November 14, 2014

AEP-NRC-2014-65
10 CFR 50.90
10 CFR 50.67

Donald C. Cook Nuclear Plant, Units 1 and 2
LICENSE AMENDMENT REQUEST TO ADOPT TSTF-490, REVISION 0,
"DELETION OF E BAR DEFINITION AND REVISION TO REACTOR COOLANT SYSTEM
SPECIFIC ACTIVITY TECHNICAL SPECIFICATION" AND IMPLEMENT FULL-SCOPE
ALTERNATIVE SOURCE TERM

Figure 3.4.16-1 (page 1 of 1)
Reactor Coolant DOSE EQUIVALENT I-131 Specific Activity
Limit Versus Percent of RATED THERMAL POWER

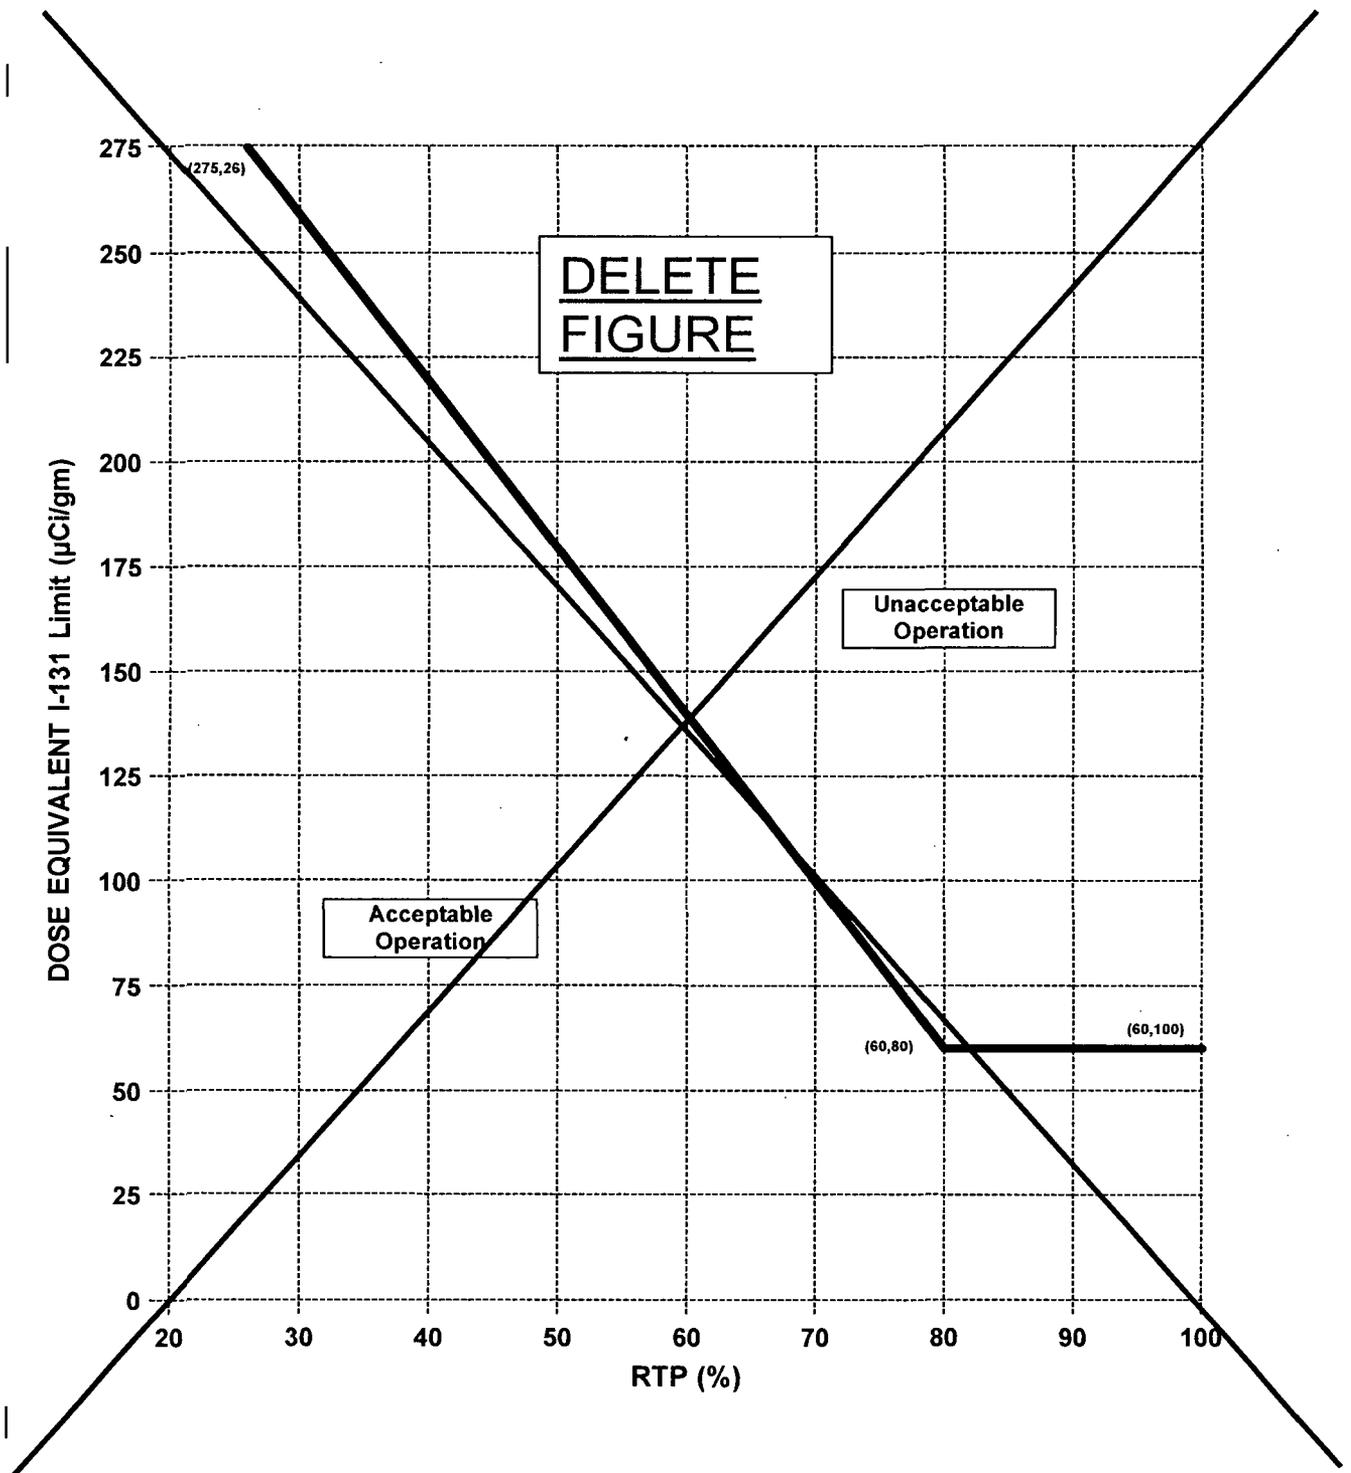
- Revise LCO 3.4.16 “Applicability” to specify the LCO is applicable in MODES 1, 2, 3, and 4.
- Modify ACTIONS Table as follows:
 - A. Condition A is modified to delete the reference to Figure 3.4.16-1, and define an upper limit that is applicable at all power levels.

~~With the DOSE EQUIVALENT I-131 greater than the LCO limit, samples at intervals of 4 hours must be taken to verify that the limits of Figure 3.4.16-1 are not exceeded. An isotopic analysis of a reactor coolant sample must be performed for at least I-131, I-133, and I-135. The Completion Time of 4 hours is required to obtain and analyze a sample. Sampling is done to continue to provide a trend.~~

~~If any Required Action and associated Completion Time of Condition A is not met, if the DOSE EQUIVALENT I-131 is in the unacceptable region of Figure 3.4.16-1, or if gross specific activity of the reactor coolant is not within limit, the reactor must be brought to MODE 3 with RCS average temperature < 500°F within 6 hours. The Completion Time of 6 hours is reasonable, based on operating experience, to reach MODE 3 below 500°F from full power conditions in an orderly manner and without challenging unit systems.~~

With the DOSE EQUIVALENT I-131 greater than the LCO limit, samples at intervals of 4 hours must be taken to demonstrate that the specific activity is $\leq 60.0 \mu\text{Ci/gm}$. The Completion Time of 4 hours is required to obtain and analyze a sample. Sampling is continued every 4 hours to provide a trend.

If the Required Action and associated Completion Time of Condition A or B is not met, or if the DOSE EQUIVALENT I-131 is > 60.0 µCi/gm, the reactor must be brought to MODE 3 within 6 hours and MODE 5 within 36 hours. The allowed Completion Times are reasonable, based on operating experience, to reach the required plant conditions from full power conditions in an orderly manner and without challenging plant systems.

Figure 3.4.16-1 (page 1 of 1)
Reactor Coolant DOSE EQUIVALENT I-131 Specific Activity
Limit Versus Percent of RATED THERMAL POWER

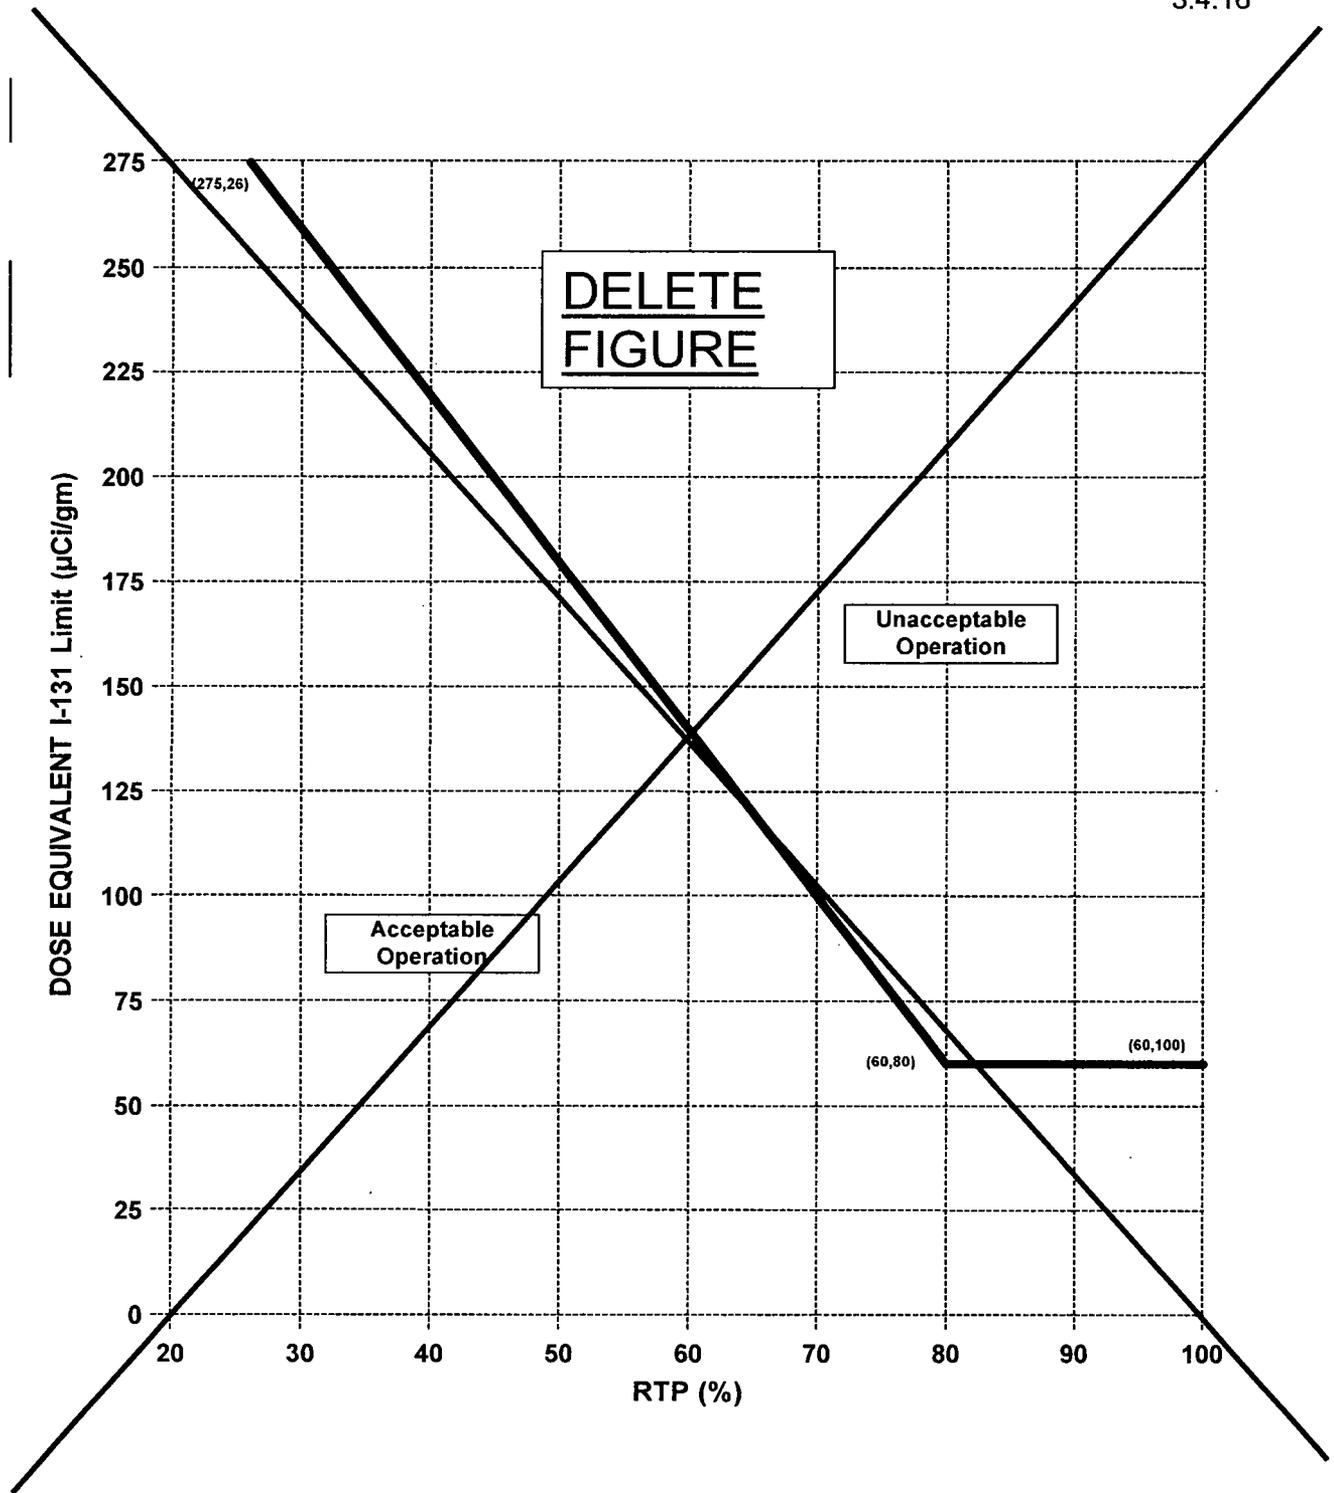
~~With the DOSE EQUIVALENT I-131 greater than the LCO limit, samples at intervals of 4 hours must be taken to verify that the limits of Figure 3.4.16-1 are not exceeded. An isotopic analysis of a reactor coolant sample must be performed for at least I-131, I-133, and I-135. The Completion Time of 4 hours is required to obtain and analyze a sample. Sampling is done to continue to provide a trend.~~

~~If any Required Action and associated Completion Time of Condition A is not met, if the DOSE EQUIVALENT I-131 is in the unacceptable region of Figure 3.4.16-1, or if gross specific activity of the reactor coolant is not within limit, the reactor must be brought to MODE 3 with RCS average temperature < 500°F within 6 hours. The Completion Time of 6 hours is reasonable, based on operating experience, to reach MODE 3 below 500°F from full power conditions in an orderly manner and without challenging unit systems.~~
